**CITY OF BATON ROUGE
PARISH OF EAST BATON ROUGE**

ADDENDUM NO. 3

**BATON ROUGE BUS RAPID TRANSIT PROJECT
(NICHOLSON DR. – FLORIDA BLVD. – PLANK RD.)
(CITY PARISH PROJECT NO. 16-CI-US-0032)**

STATION CIVIL PLAN
 "ASTER ST" - NORTHBOUND
 NICHOLSON DR AT ASTER ST
 PLANK-NICHOLSON BUS RAPID TRANSIT

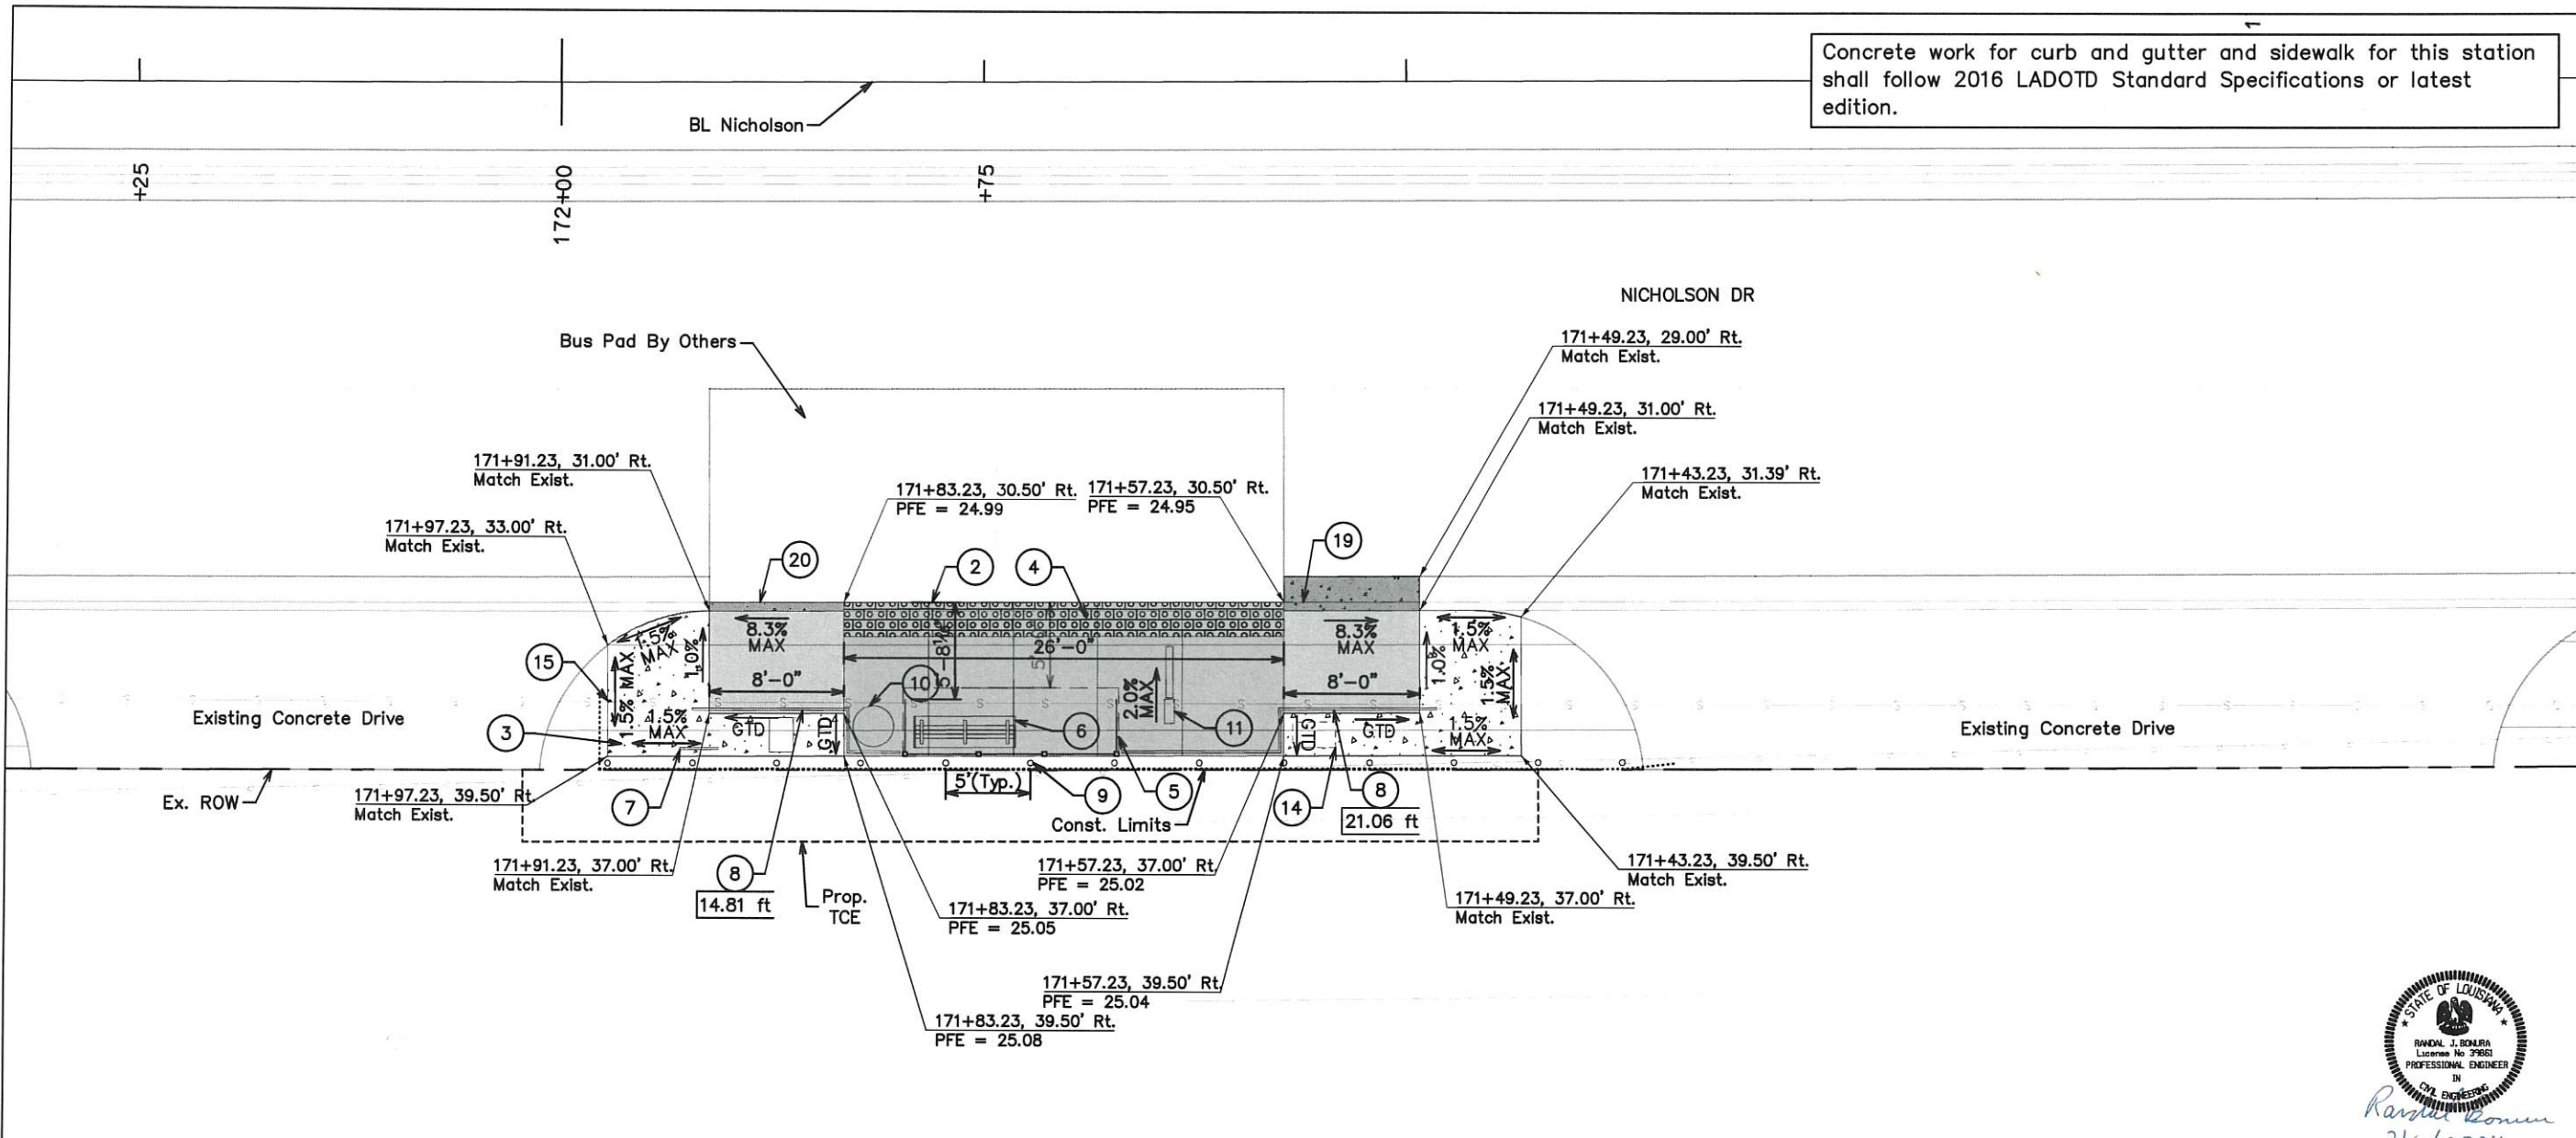
- f. THE CONTRACTOR IS RESPONSIBLE FOR ENSURING POSITIVE DRAINAGE AROUND THE STATION.
- g. SEE DETAIL 1 ON SHEET 292 FOR STEEL BOLLARDS.

STATION CIVIL PLAN
 "RENAISSANCE PARK" - EASTBOUND
 FLORIDA AT ST. VINCENT DE PAUL
 PLANK-NICHOLSON BUS RAPID TRANSIT

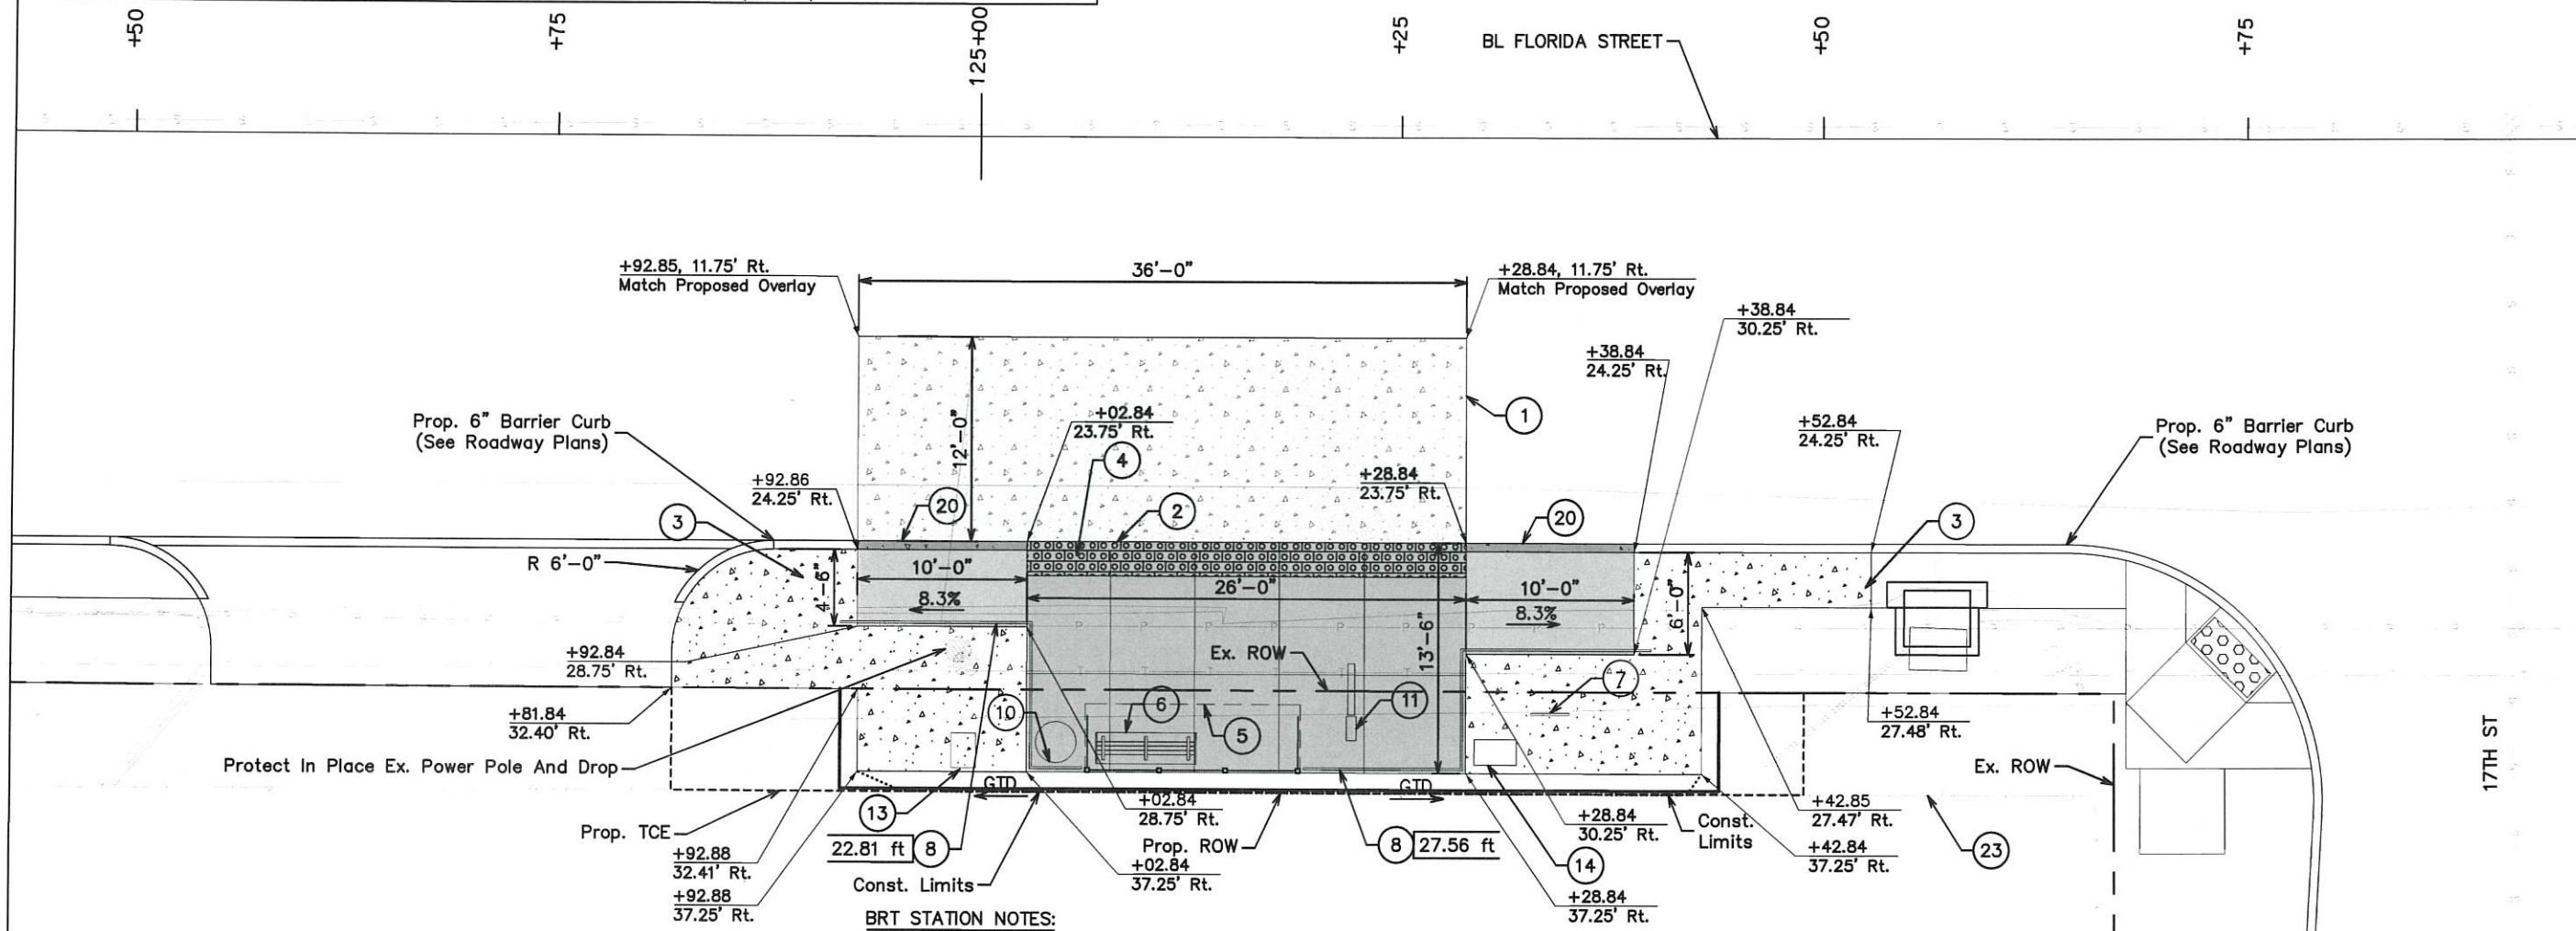
17. Plan sheets 253 and 255 reference sheet 192 Detail #3, but this does not exist. Please provide detail.

Please refer to sheet 288 Detail 3. See revised plan sheets 253 and 255 in this Addendum No. 3.

1 STEEL BOLLARD
NOT TO SCALE

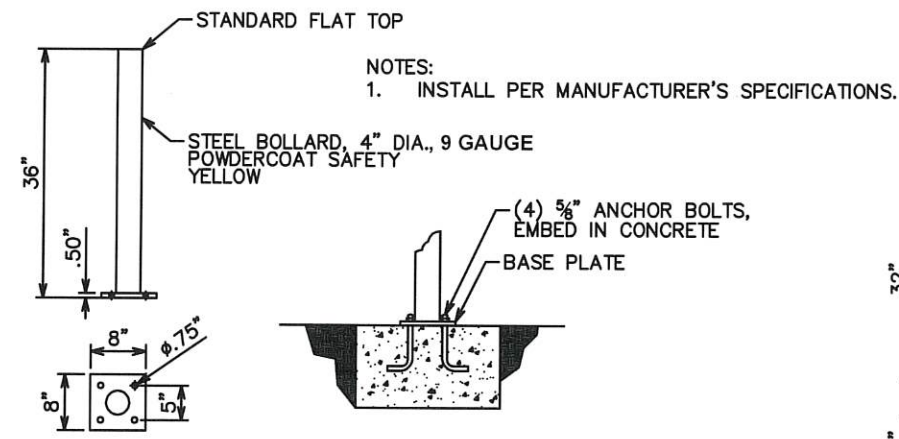
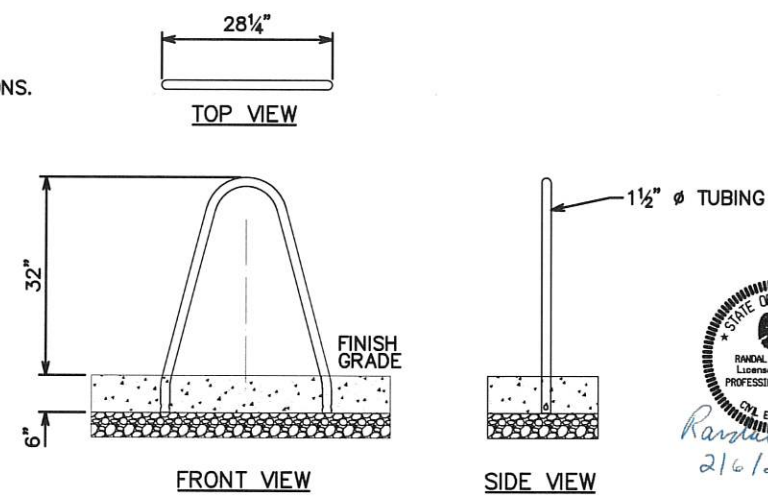
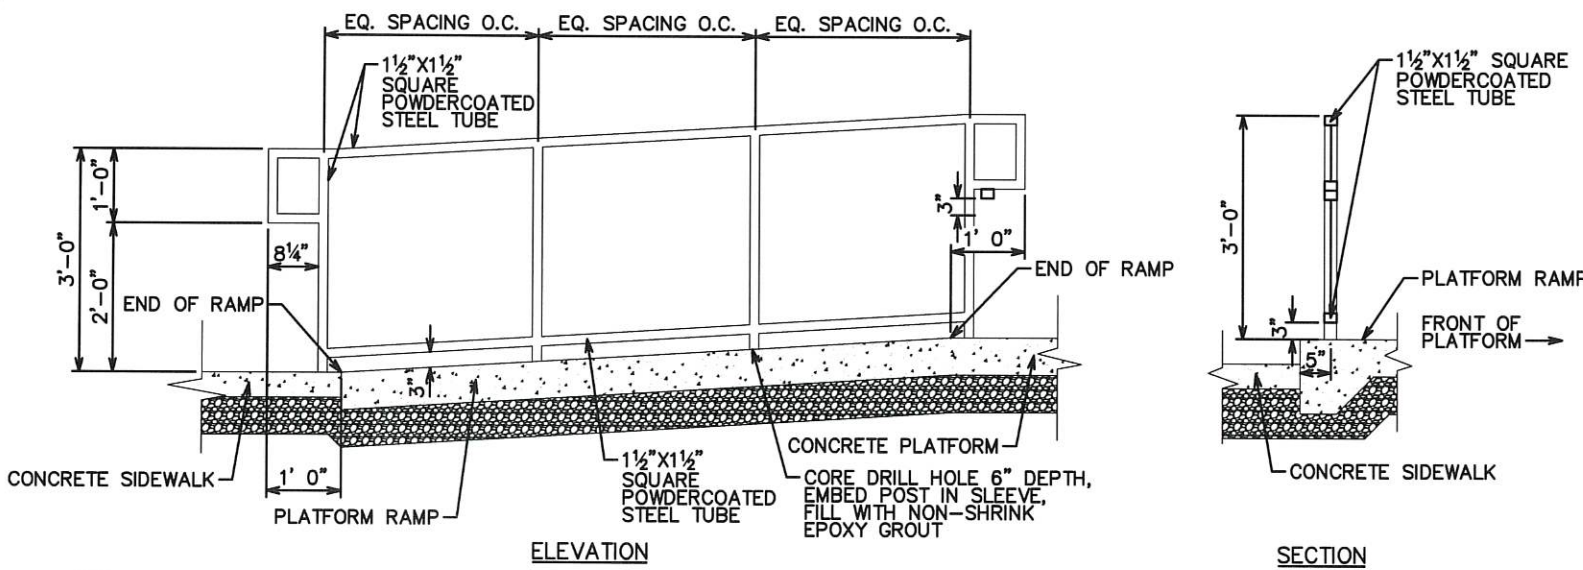
3. Please provide a specification for bollards. Requested information would include size of bollard, gauge, and if any painting or bollard covers are needed.

Refer to detail 1 on revised sheet 292 included in this Addendum No. 3.
